Royds Hall Community School

Section 278
Longwood Road, Clough
Lane Victory Avenue &
Luck Lane Layout

Drawing No. LDH/2129/721	Revision P2
------------------------------------	-----------------------

Drawing No. LDH/2129/721-P2

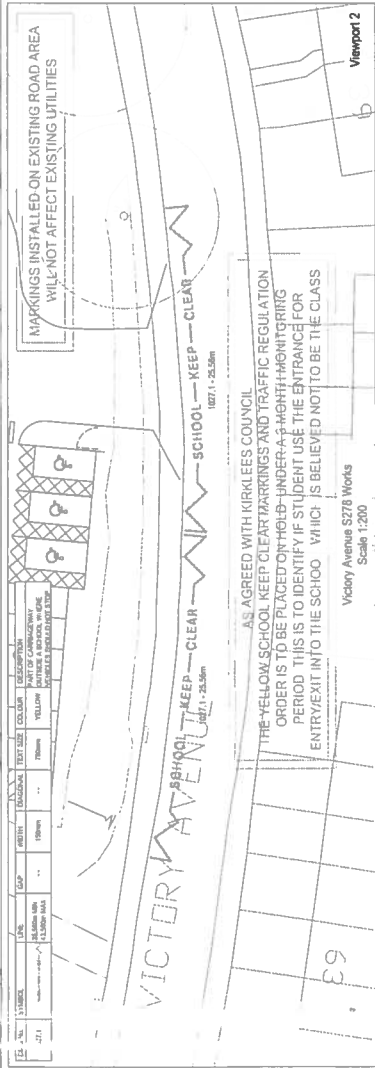
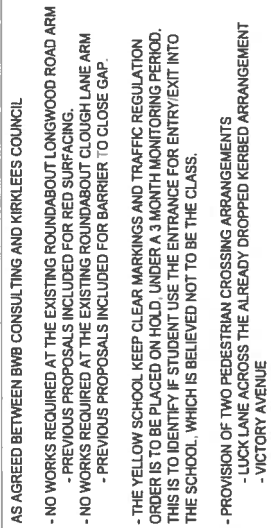
With regard to suggested School Way Clear markings - these are only suitable where children cross in numbers. The restriction on Victory Ave (if provided) would probably be No Waiting / No Loading. Length to be determined, heavy in mind parking will be displaced elsewhere.

SAFETY MEMOS COMMENTS NOTED. FURTHER INVESTIGATION INTO ROADWORKS AND TUE OF WORKING TO UNDERTAKE ONCE THE SCHOOL IS IN OPERATION
